REGULAR MEETING OF THE PLAN COMMISSION OF THE VILLAGE OF WILLOWBROOK TO BE HELD ON WEDNESDAY, JANUARY 13, 2016 AT 7:00 P.M. AT HINSDALE SOUTH HIGH SCHOOL, LITTLE THEATER, 7401 CLARENDON HILLS ROAD, CITY OF DARIEN, DUPAGE COUNTY, ILLINOIS

STAFF REPORT TO THE PLAN COMMISSION

Action Requested: Conduct public hearing for a petition requesting a special use for a Planned Unit Development (PUD) that allows the reuse of part of the existing vacated K-Mart building on the northeast corner of Plainfield and Route 83 as a multi-tenant building (current plans for Pete's Fresh Market, Steinmart and Ulta), and construction of a new multi-tenant commercial building that parallels Plainfield Road, including both on-site improvements and offsite improvements to both Plainfield Road and Route 83, and approval of a preliminary and final plat of subdivision.

North Property Line Setbacks

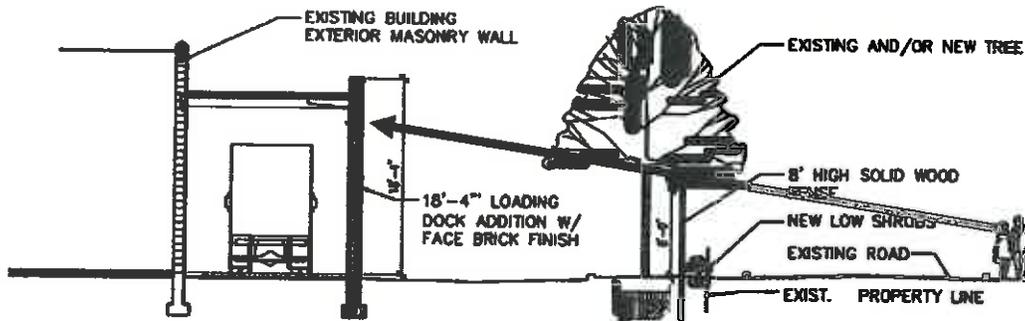
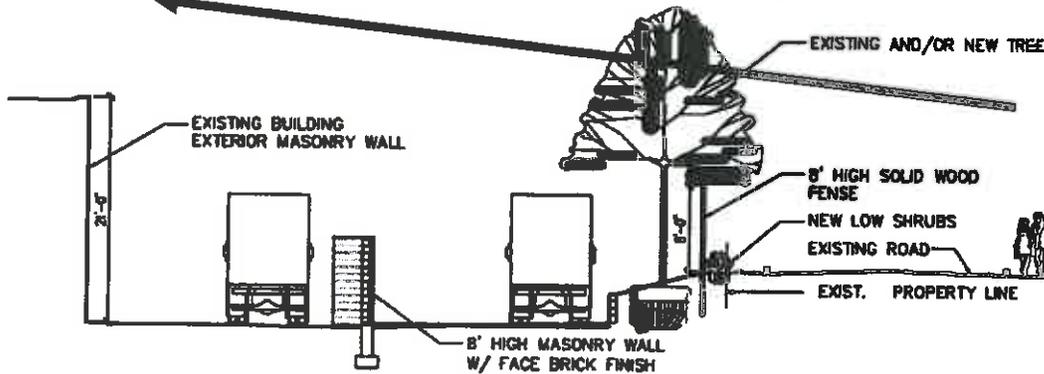
Some of the most significant exceptions identified as part of this project are those that already exist. Both the building and parking lot setbacks from the north property line do not meet the requirements of being next to residentially zoned property. These locations, however, are fixed. In an effort to address possible concerns and meet the spirit of the ordinance, the applicant located its grocery store operation as far away from residents as possible at the west end of the building, and is proposing to fully enclose its loading and garbage areas. Deliveries and garbage for the department store and the cosmetic store are much less frequent and intense, so the area is not being fully enclosed, but is being screened with new loading area screen walls. In addition, the applicant is proposing to replace the existing slatted 5' tall chain link fence with a new 8' tall screen wall. The existing fence is shown in the two pictures below. Note the higher elevation of the fence at the east end of the property, which is closer to the residents. The fence at the west end of the property gets closer to matching the grade of the property to the north. The effects of these grades on how people view the development is shown in the illustrations on the next page. The top of the building can be seen over the fence at the west end, but not at the east end, which is why loading areas are roofed at the west end and not the east end.

The existing fence is on the property line as opposed to being set back ten feet (10') as the Ordinance would now require for new conditions. The applicant has agreed to provide new landscaping on both sides of the fence to provide additional screening and buffer the visual impact of a tall fence. Staff is also recommending that the fence be modified from its current proposed wooden board on board styled fence to something that weathers well. The applicant may select to utilize stained cedar, a "wood-like" solid composite or a simulated stone fence similar to one of the fences in the pictures below. These will not only be more attractive visually, but will also require less maintenance over time.

Monument Signage

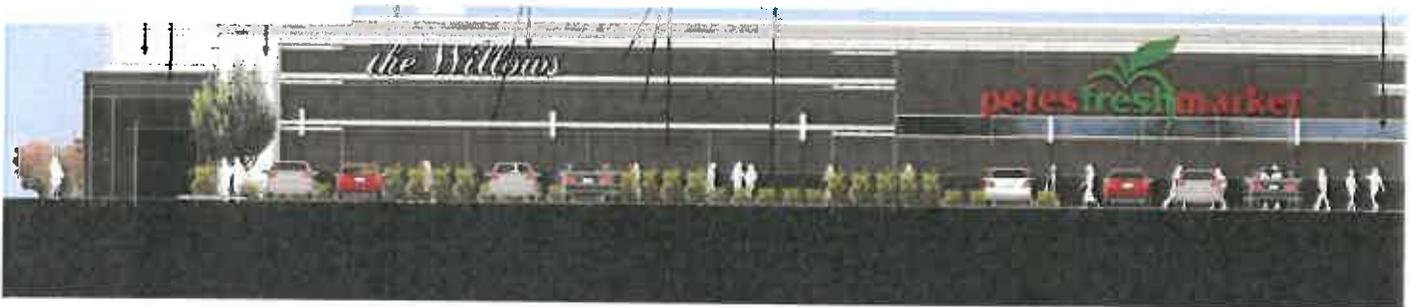
Two monument Signs are proposed. One at the Plainfield Road entrance and one at the southern Route 83 entrance. The sign staff last discussed with the applicant is shown below. It is designed to generally the height (24') and area requirements of the ordinance. The "Pete's Fresh Market, including the digital sign underneath is 8' x 12'8". The overall width of the sign (including cantilever) is 16'. The digital portion of the sign is proportionate to the rest of the sign. It will be important that documentation is added that specifies that no part of the sign from top to bottom (including the portion of the sign that cantilevers out from the rest of the sign) is closer than five feet (5') to any lot line.

Eight sign panels are shown under the sign, and staff has recommended on more than one occasion that they not utilize such small panels to identify so many users, as they are hard to read and ineffective. Staff has instead encouraged the applicant to utilize the digital sign to advertise the smaller tenants in the outlot building. Given, however, that the sign meets size requirements, staff

does not object to the multiple sign panels if that is how the applicant would like to proceed. The only other suggestion on the monument sign is to add a town and/or shopping center identifier. Adding "The Willows of Willowbrook" individual indirectly lit lettering as allowed by the code underneath the tenant panel area would provide motorists with a common identifier for the shopping center. This would be identification in addition to what the applicant has proposed, which is to add "The Willows" on the west elevation facing Route 83 and the north end of the building as shown in the picture below the monument sign below.

Finally, the plans should provide clarification as to how the overhead wires along Plainfield are located or being re-located so as not to interfere with the monument sign at that entrance.

REVISIONS:		DATE:		NO.		DESCRIPTION:	
03-17-2015		08-18-2015		1		PER VILLAGE REVIEW COMMENTS DATED 12-17-14	
				2		PER CLIENT REVISIONS	
DRAWN: K.B.		DATE: 05-30-14		CHECKED: A.R.G.		DATE:	
ENG PROJ #14-04		SURV PROJ #		FIELD BOOK:		DATE:	
						SHEET: C-10

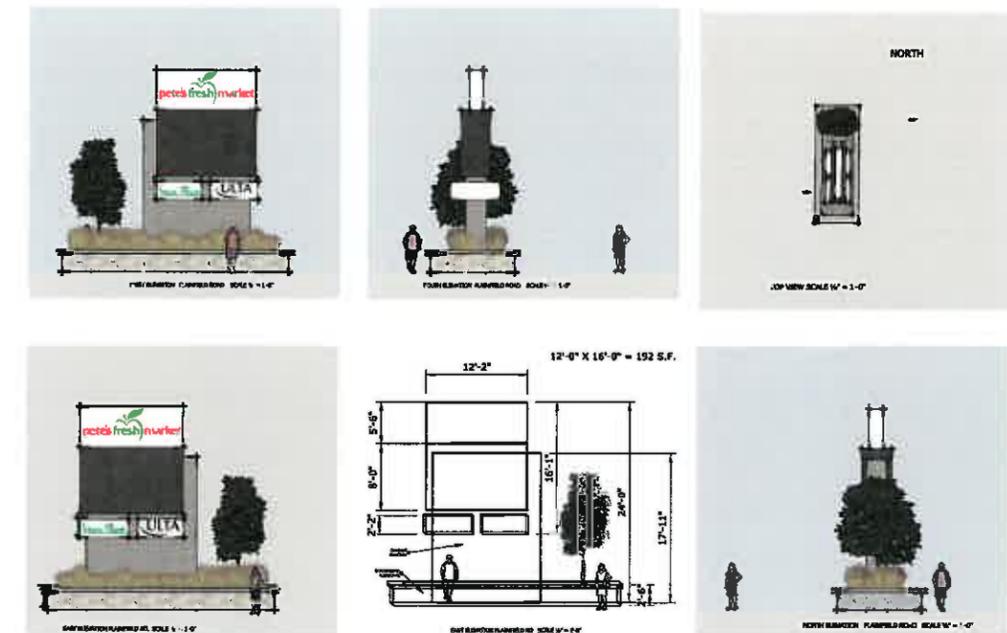
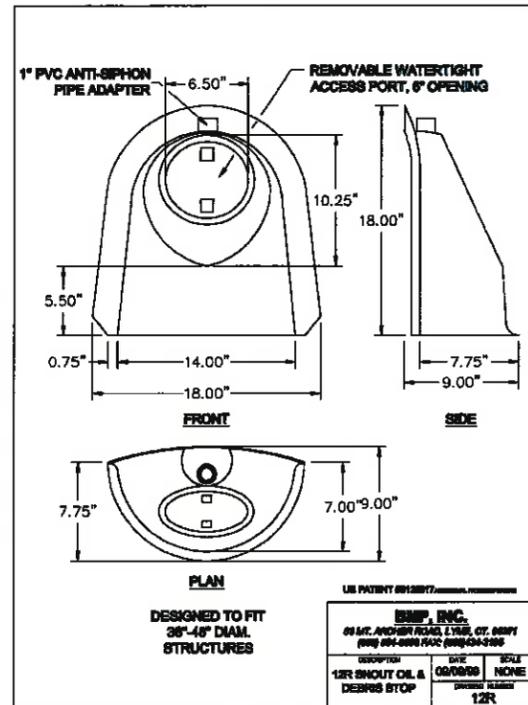
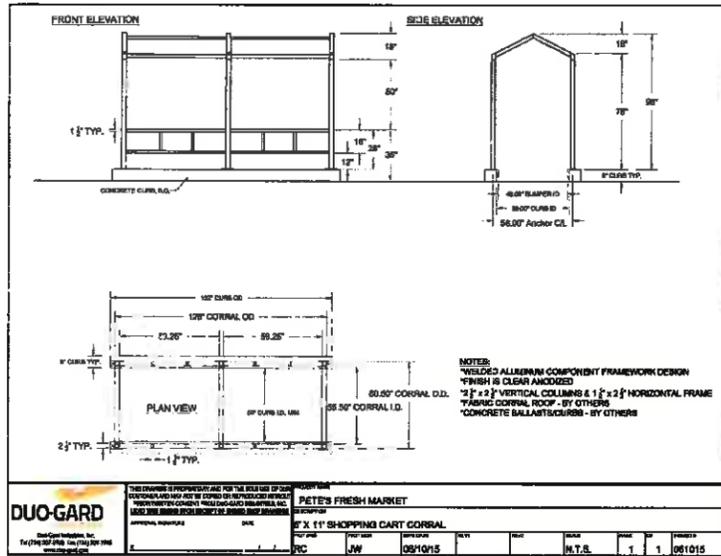
Please note that the latest Engineering Plans (Page C-10) submitted for this review, have proposed a different monument sign than discussed above and that has not been discussed with staff. Staff does not support this revised sign for several reasons. It extends above the base of the sign and the digital portion of the sign is too dominant based on the general parameters discussed as part of the Willowbrook Square sign. Staff recommends something more in line with the sign shown above instead.
